M17	BT00.00-X-1000Z	Technical modifications	1.7.99
------------	-----------------	--------------------------------	---------------

BT05.20-P-0001-01A	Bolts for attaching camshaft housing to cylinder head discontinued		N17
BT01.30-P-0001-01A	Material of cylinder head gasket modified		P17
BT01.40-P-0001-01A	End cover with vulcanized radial seal		A18

Engine 604

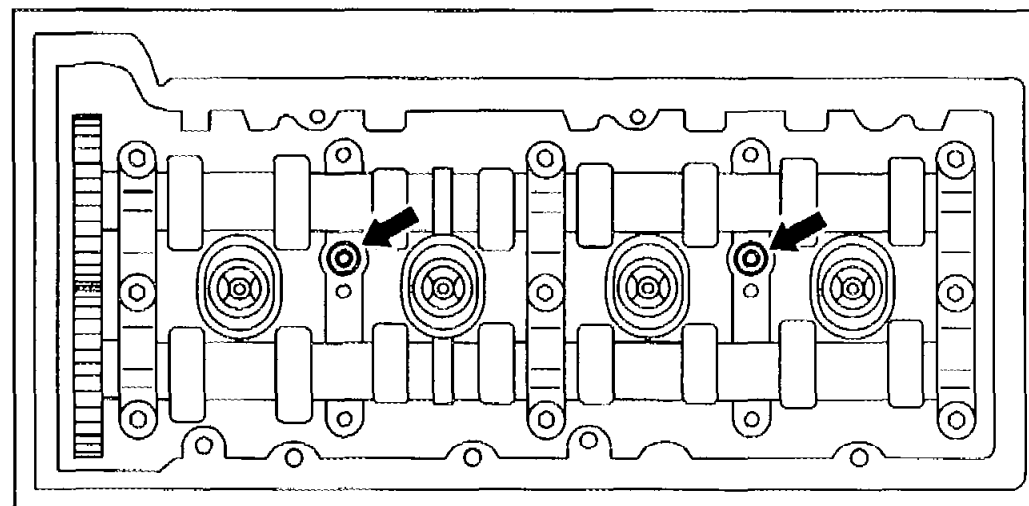
Bolts (arrows) for attaching camshaft housing to cylinder head discontinued.

**Engine 605**

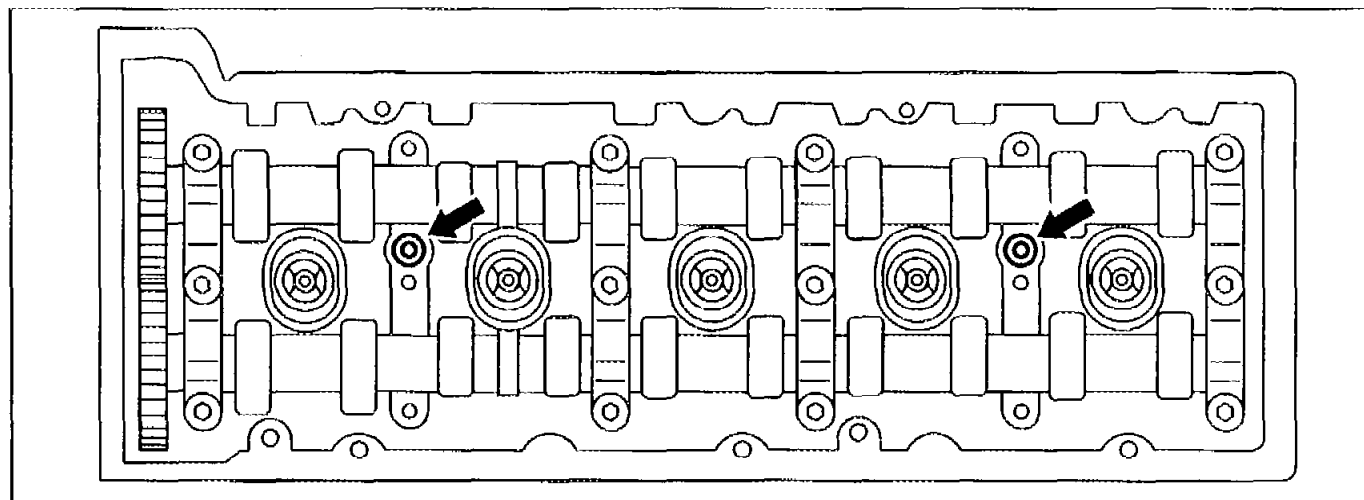
Bolts (arrows) for attaching camshaft housing to cylinder head discontinued.

Engine 606

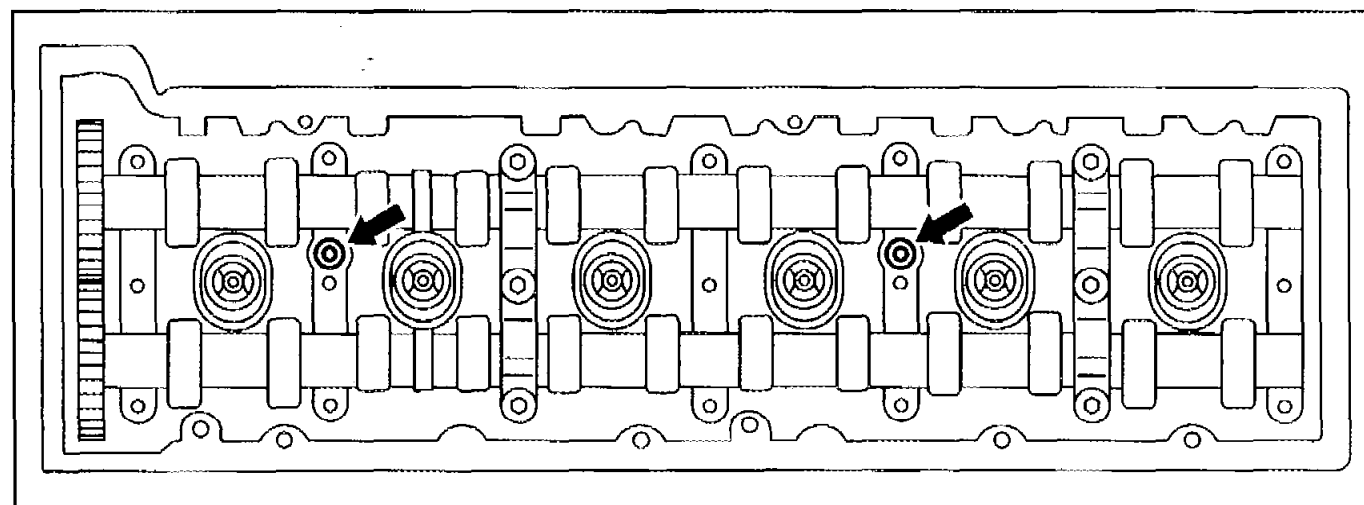
Bolts (arrows) for attaching camshaft housing to cylinder head discontinued.
